PRJ-1087614

2734 Bordeaux Avenue | September 9, 2026 | Item 10 |

Stephanie Smith, Grid Legal PC | Scott Williams, Seltzer Caplan McMahon Vitek

Proposed Site Plan

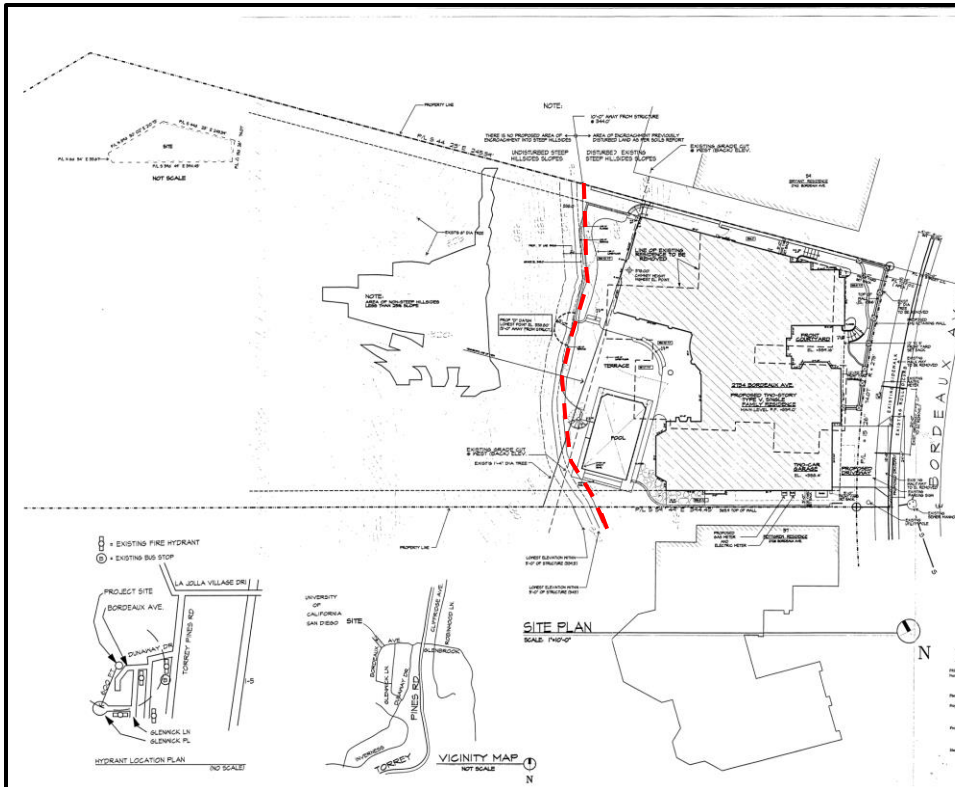
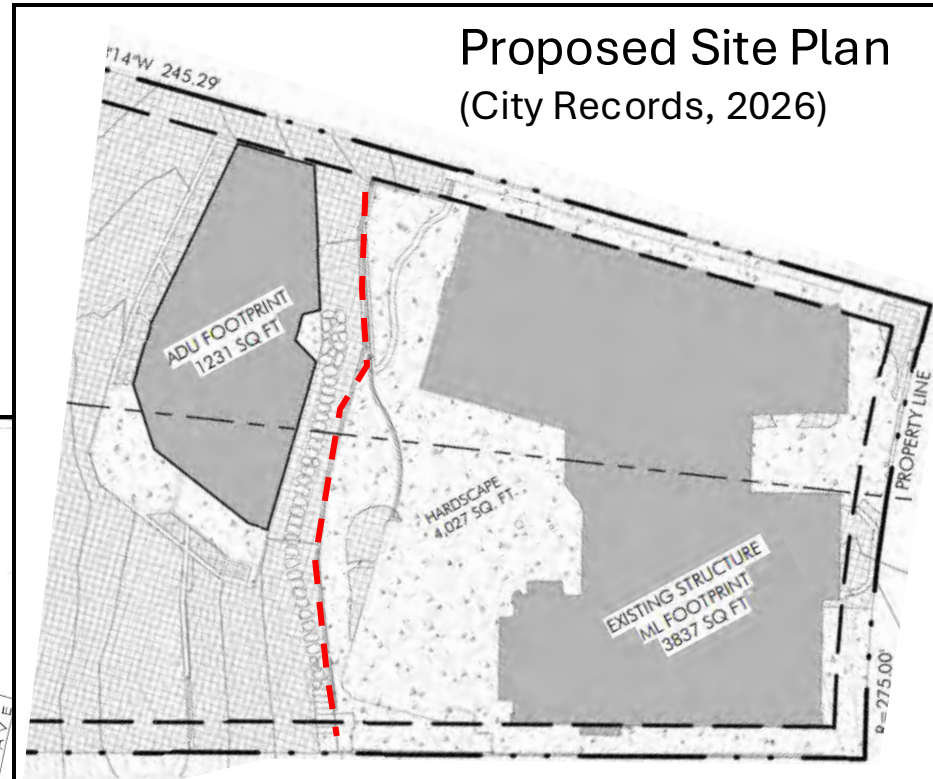
Extension onto Steep Hillsides

- (4) Within the Coastal Overlay Zone, *steep hillsides* shall be preserved in their natural state and *coastal development on steep hillsides* containing *sensitive biological resources* or mapped as Viewshed or Geologic Hazard on Map C-720 shall avoid encroachment into such *steep hillsides* to the maximum extent possible.

Protected ESL

Extension into Protected Lands

SITE DIAGRAM

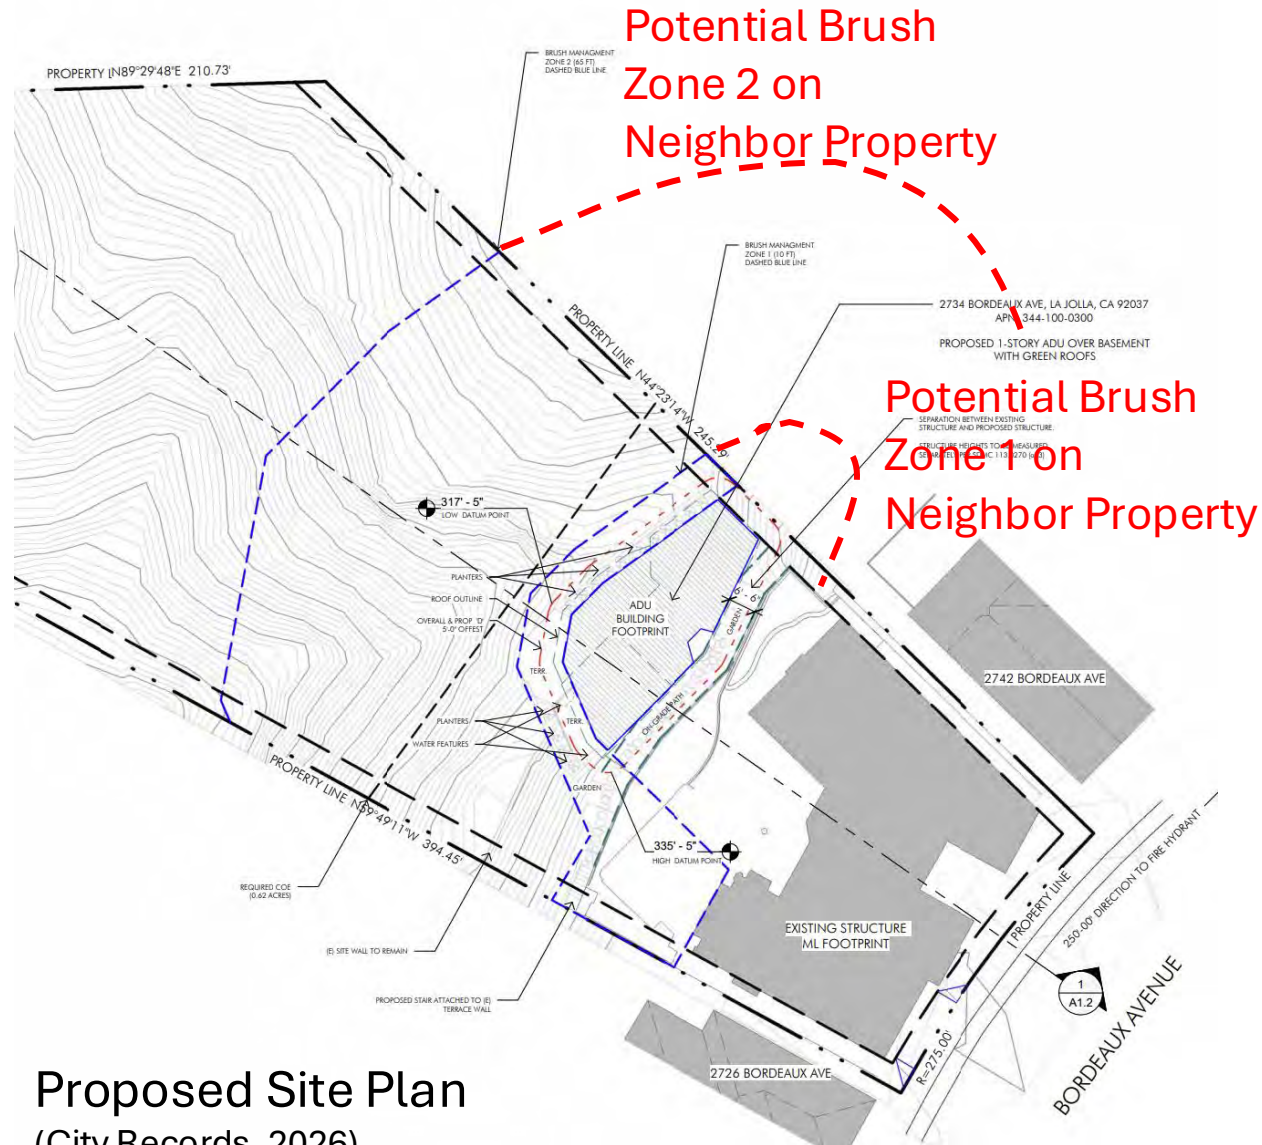
Conservation Easement is required to Avoid Crotch's Bumblebee Impacts, a non- MSCP covered species.

Brush Management 2 cannot be allowed in an area designated for habitat mitigation. SDMC §142.0412(c)(3)

“Brush Management Zone 2 thinning outside the MHPA which affects non-covered species is potentially significant” (2025 Applicant Bio Report p. 14)

Proposed Site Plan
(City Records, 2026)

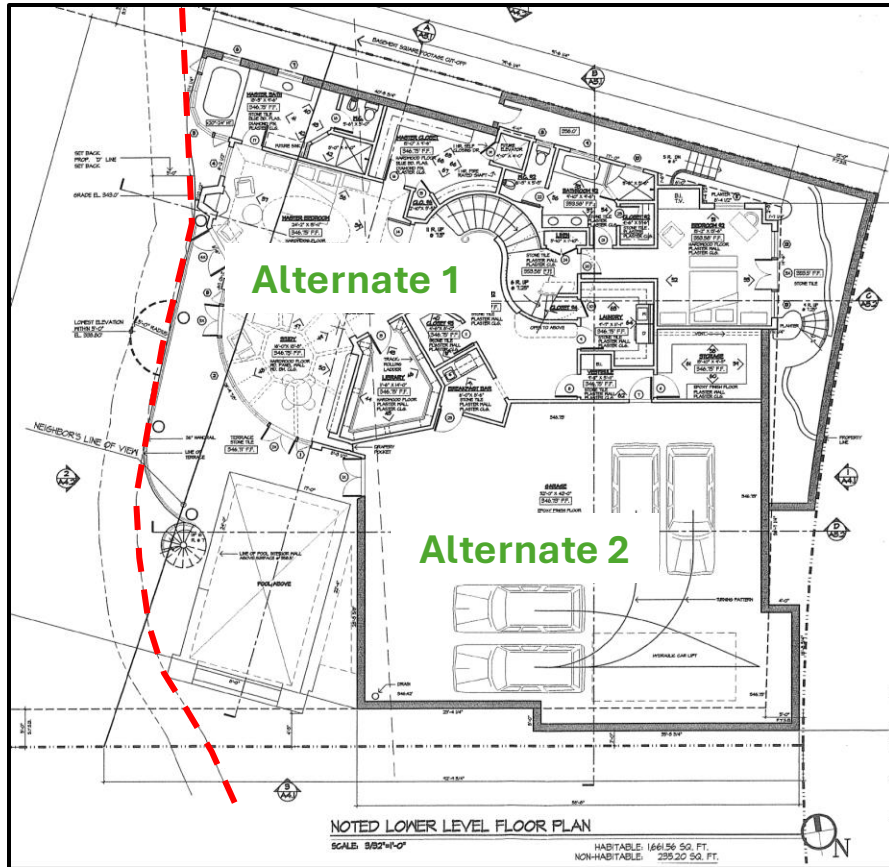
Brush Management on Adjacent Property

City Requires applicants to obtain an easement for Brush Management Zones 1 or 2 on neighboring property.
SDMC §142.0412(c)(1)

Applicant's Brush Management Plan Note 1 states: "Offsite brush management shall be the responsibility of adjacent property owners." (Brush Management Plan L 1.3, City Records 2026)

An Easement has not been obtained.

2001 CDP/SDP from City Records

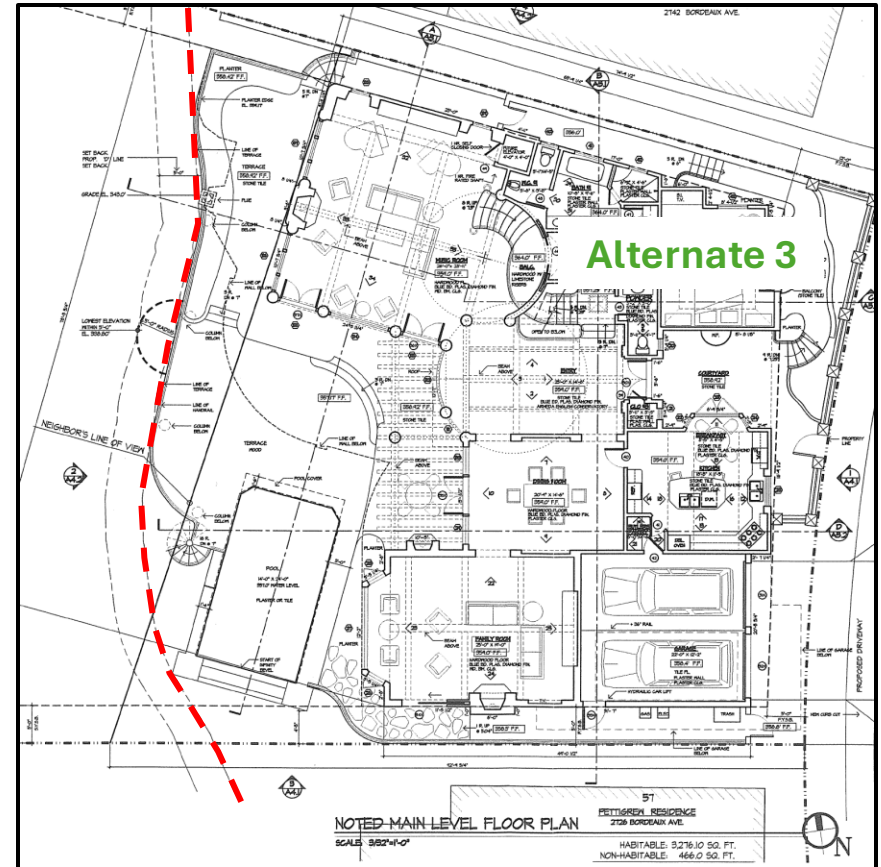
Alternative Locations for the ADU to Avoid Steep Slopes & ESL

5,617 sf 2-story residence with attached garage and 1,647 sf basement

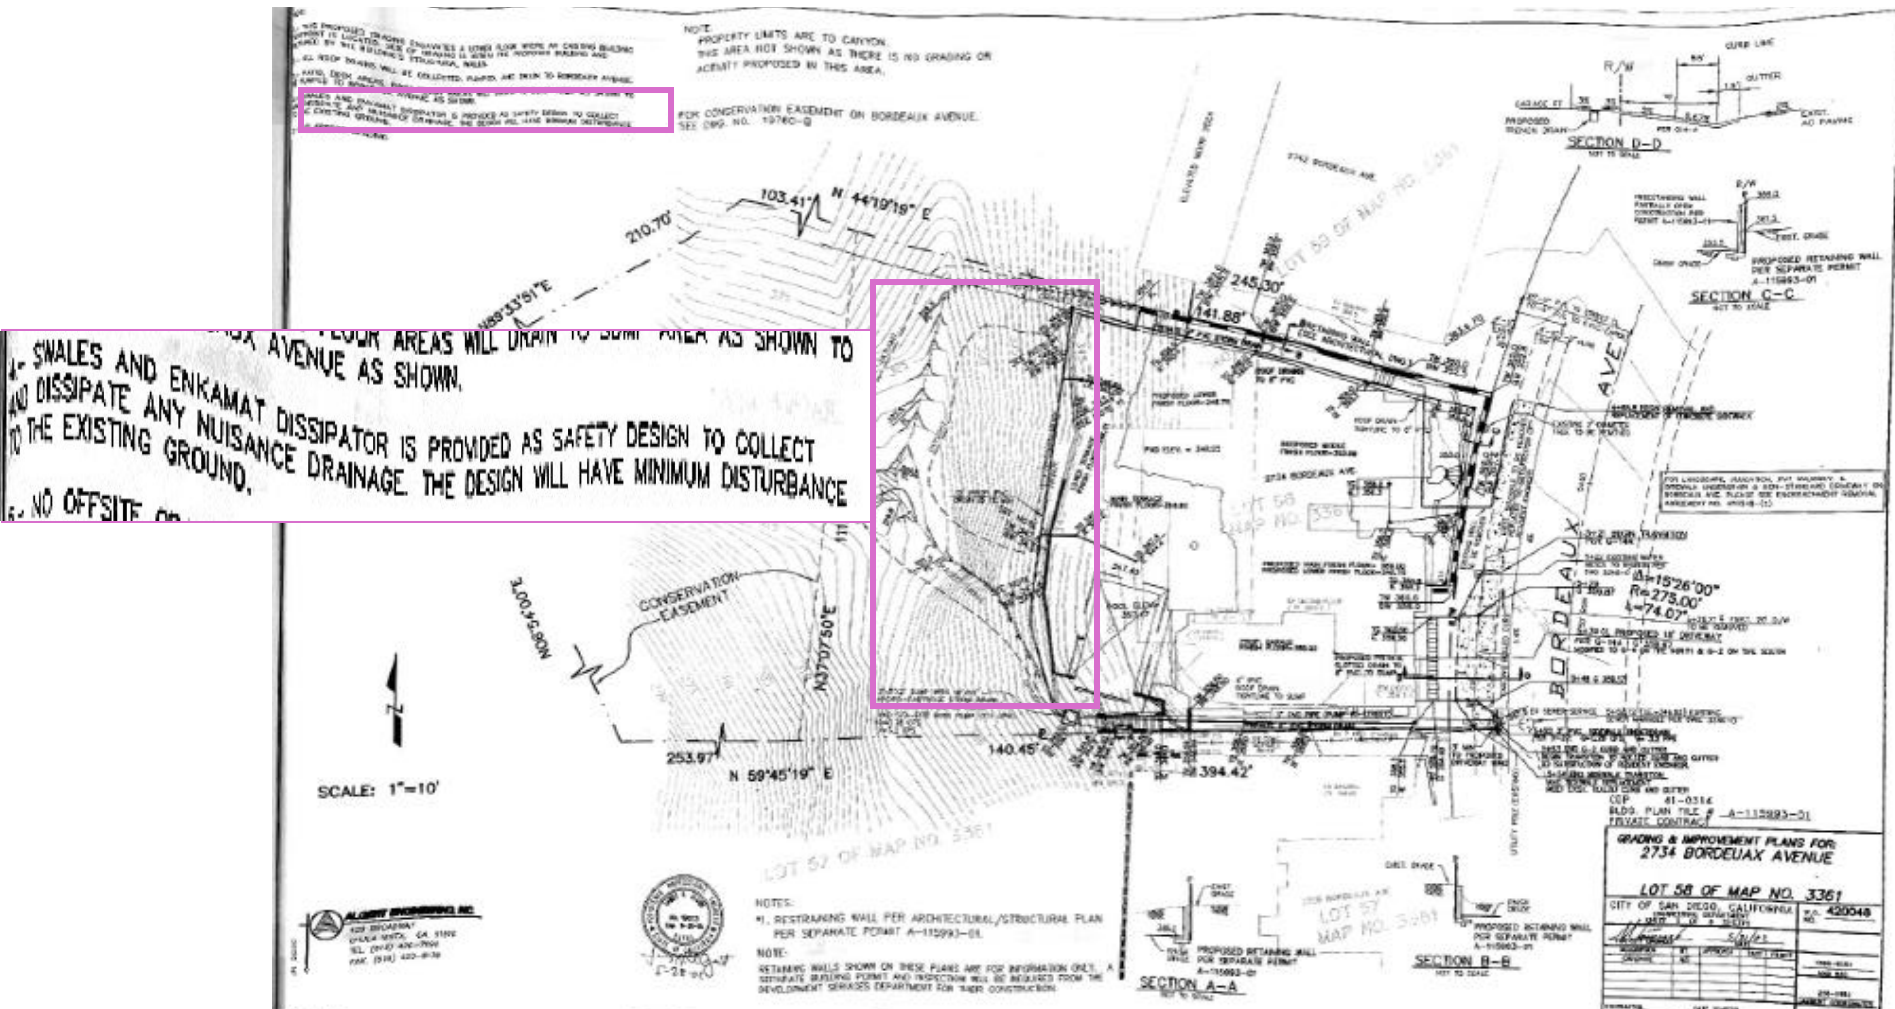
Application either relies on: 1) inaccurate information; or 2) unpermitted work

- 1) If inaccurate information → project should be denied because it fails to avoid steep hillsides
- 2) If unpermitted work → project should be continued and the unpermitted work restored (SDMC § 143.0112)

PC approved 2001 CDP/SDP for a home on the property to avoid steep slopes:

- PC Limited hillside/ESL encroachment to existing graded development line.
- Applicant claims that there is now grading beyond the 2001 CDP/SDP development line.
- City unable to locate CDP/SDP amendment or permits for any retaining wall or grading done beyond the line of development identified in the 2001 CDP/SDP.
- Applicant contends the drainage swale installation constitutes a “manufactured slope” and the area is now exempt from steep hillside avoidance.
- But drainage swale was designed to have a “minimum disturbance to the existing ground” 2001 CDP/SDP Grading Plan, Note 4, City Records 2002. Drainage swale is also not located in the area the ADU is proposed.

Proposed Grading Plan identifies unpermitted
“Exist. Retaining Wall to Remain”
(City Records, 2026)

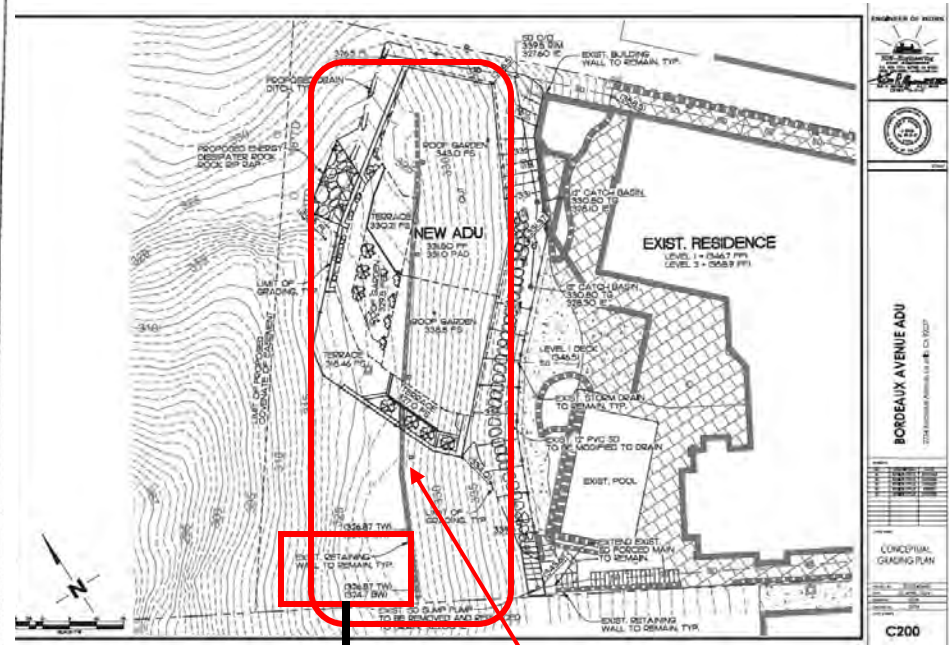
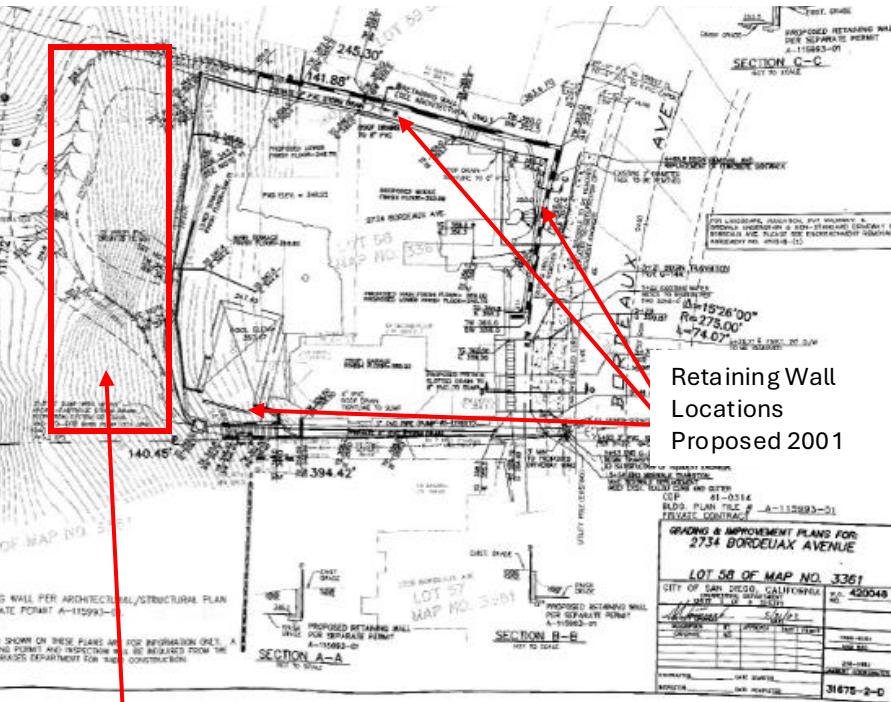
Drainage swale in 2002 Grading Plan states “design will have **minimum disturbance to the existing ground.**”(City Records, 2002).
